Re: **Fitch Park ASR Wells 5 & 6; Responses to RFI dated 2-15-19**

CALIFORNIA AMERICAN WATER
FITCH PARK ASR WELLS 5 AND 6
 ABOVE GROUND FACILITIES

DRAWING NUMBER: **M-2**

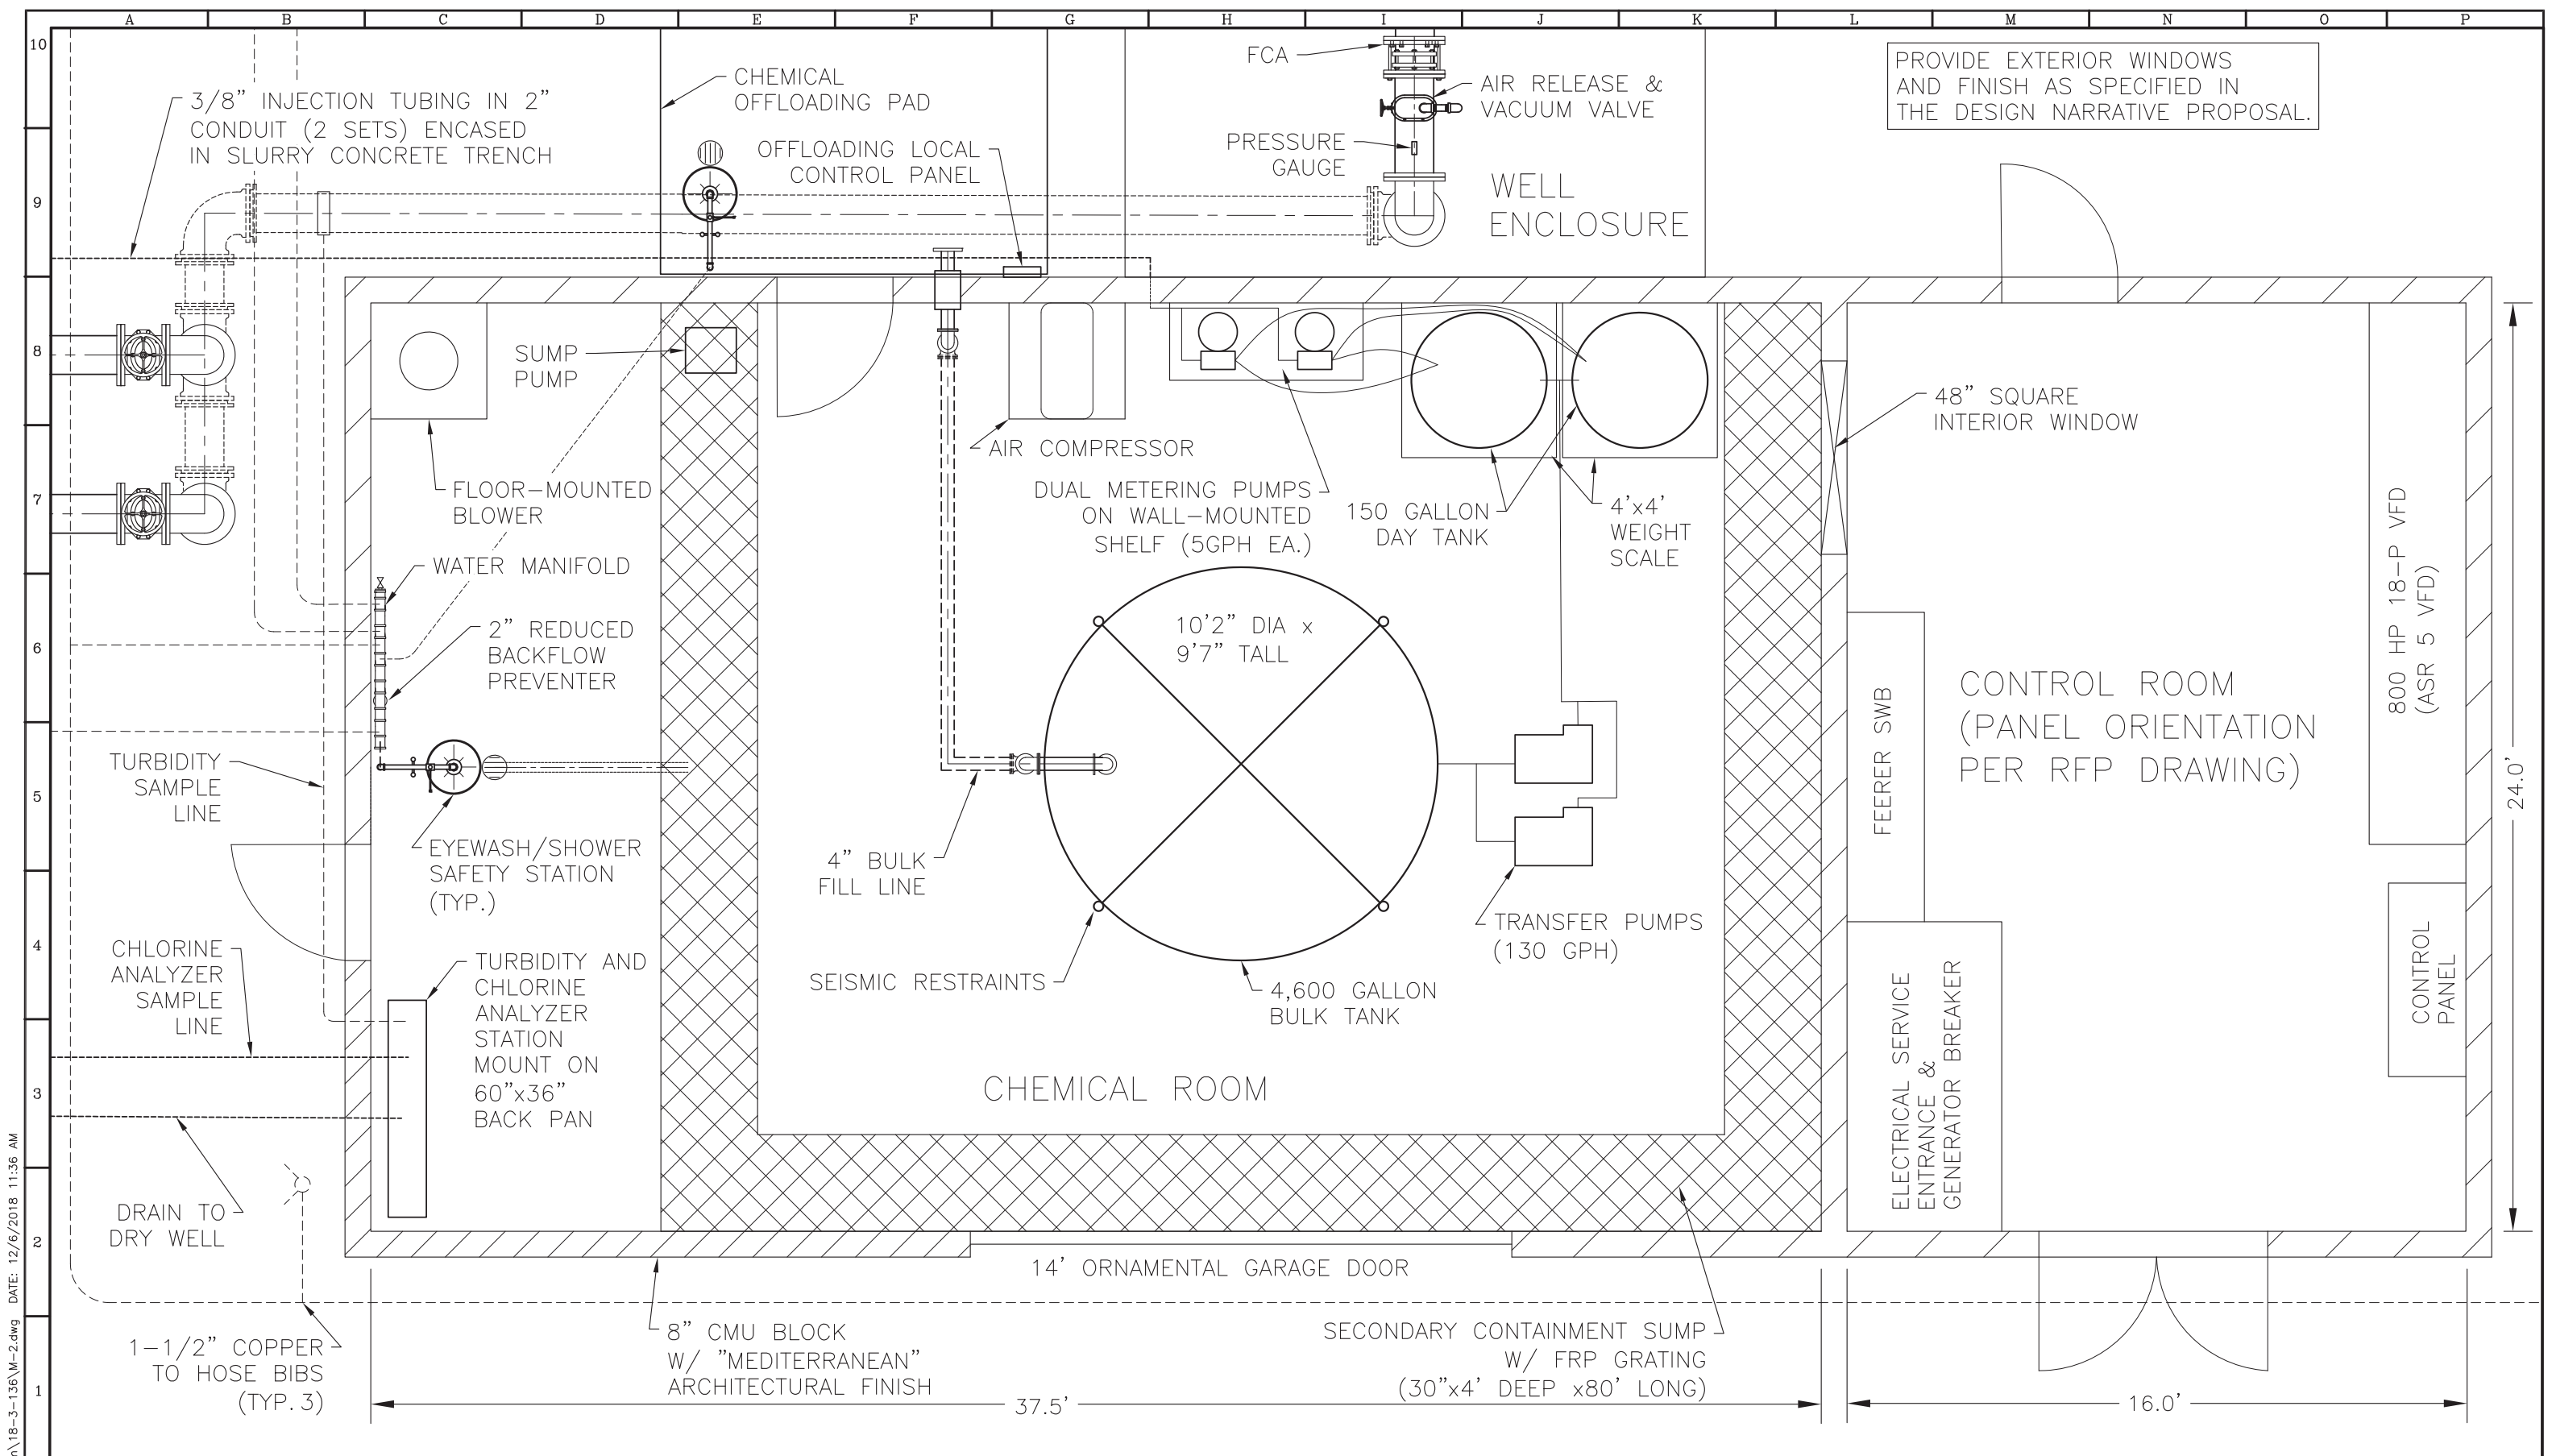
4. You requested a P&ID from our DOR (LSCE) for the Disinfection Building.

HHCI Response: Disinfection Building P&ID drawing - Drawings M-2 and P&ID I-1 are attached (Attachment 3a and 3b).
